Access Compliance Report Public Rights-of-Way (Curb Ramps)

Main Street: E_PEARL_ST Cross Street: S_ESPLANADE_ST Location: SE

ADA ID: RPAT210927134045 Ramp Type: Type 4 - Parallel Initial Pass/Fail: Fail Overall Compliance: No Severity Score: 19

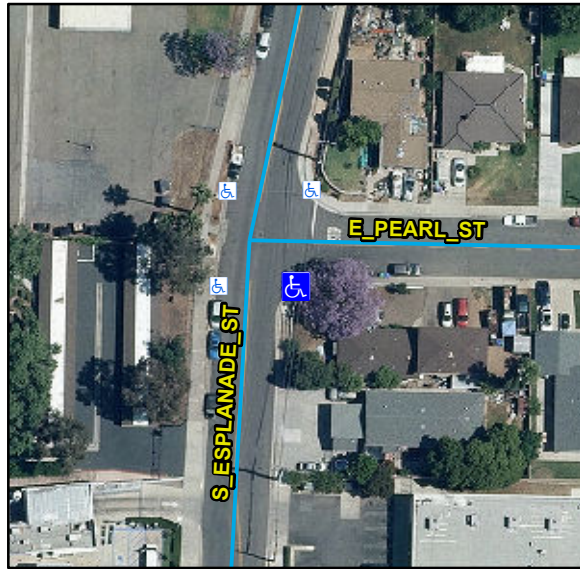
Compliance	Description	Data	Compliance	Description	Data
N/A	Ramp Length LT (in)	123	N/A	Ramp Length RT (in)	69
Yes	Ramp Width LT (in)	48	No	Ramp Width RT (in)	47
No	Ramp Run Slope LT (%)	11.1	Yes	Ramp Run Slope RT (%)	3.4
Yes	Ramp Cross Slope LT (%)	0.5	Yes	Ramp Cross Slope RT (%)	1
N/A	Landing Present	N/A	N/A	DWS Provided	N/A
N/A	Landing Length (in)	N/A	N/A	DWS Contrast	N/A
N/A	Landing Width (in)	N/A	N/A	DWS Length (in)	N/A
N/A	Landing Run Slope (%)	N/A	N/A	DWS Full Width	N/A
N/A	Landing Cross Slope (%)	N/A		DWS Offset Type	N/A
N/A	Landing Movement Obstructed?	N/A	N/A	DWS Offset Left (in)	N/A
	Landing Movement Type	N/A	N/A	DWS Offset Right (in)	N/A
N/A	Landing Shared	N/A			
N/A	Clear Space	Yes			
N/A	Clear Space To Crosswalk (in)	N/A			
N/A	Marked Crosswalk 1	No	N/A	Marked Crosswalk 2	No
	Crossing 1 Direction	N		Crossing 2 Direction	W
	Marked Crosswalk 1 Width (in)	N/A		Marked Crosswalk 2 Width (in)	N/A
N/A	Ramp Inside Crosswalk 1	N/A	N/A	Ramp Inside Crosswalk 2	N/A

Remove & Replace Curb Ramp With Two New Directional Ramps or Equivalent.

R304.5.1, R304.3.2, STD 1115
